NOTICE

Additional Operating Instructions for KX-T7400 Series and Added and Changed Features for the Operating Instructions for the KX-TD208E

User Manual Addendum for KX-T7400 Series

Flow Chart of LCR

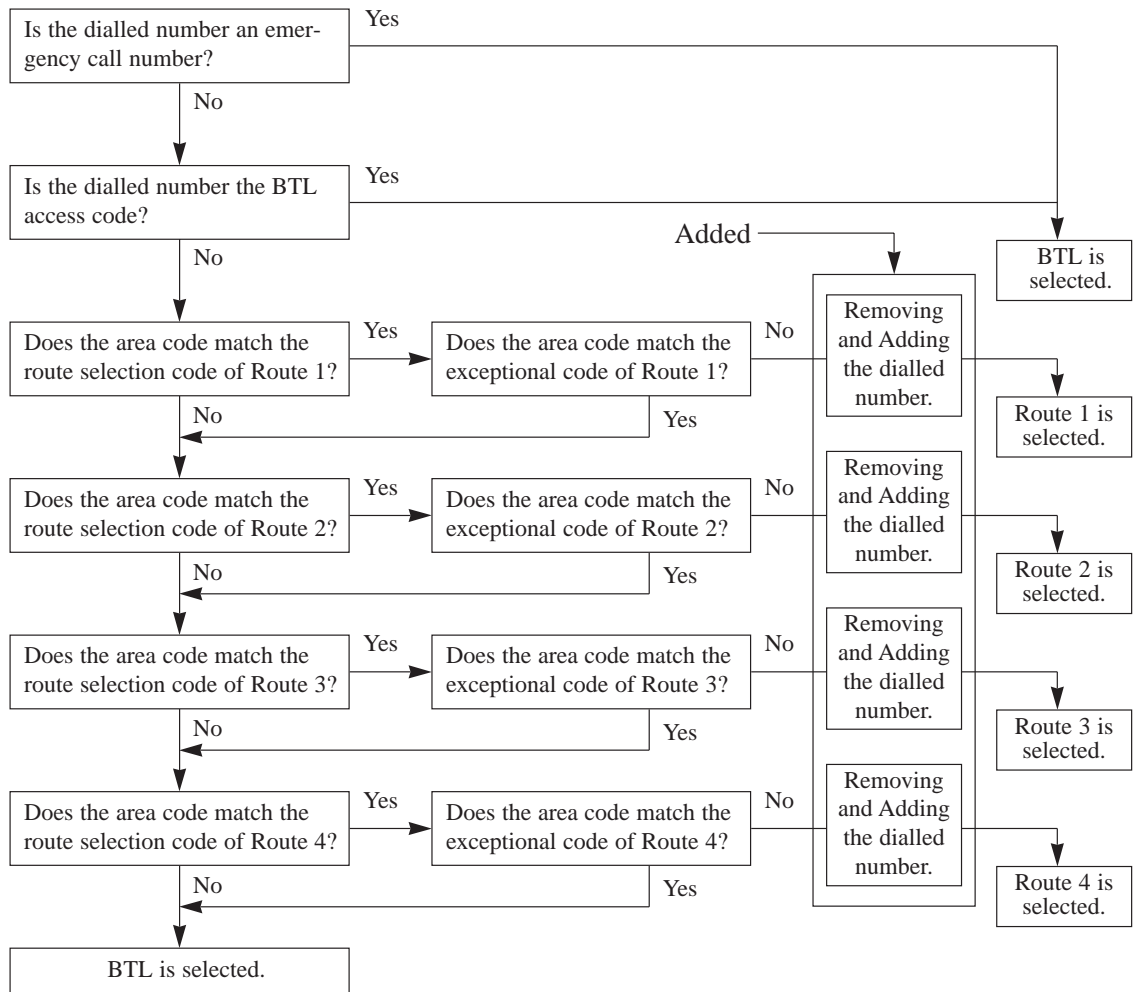
Least Cost Routing P. 48 Please delete the third box from the top, “Does the first digit match the leading digit?”. Please use the following flow chart.
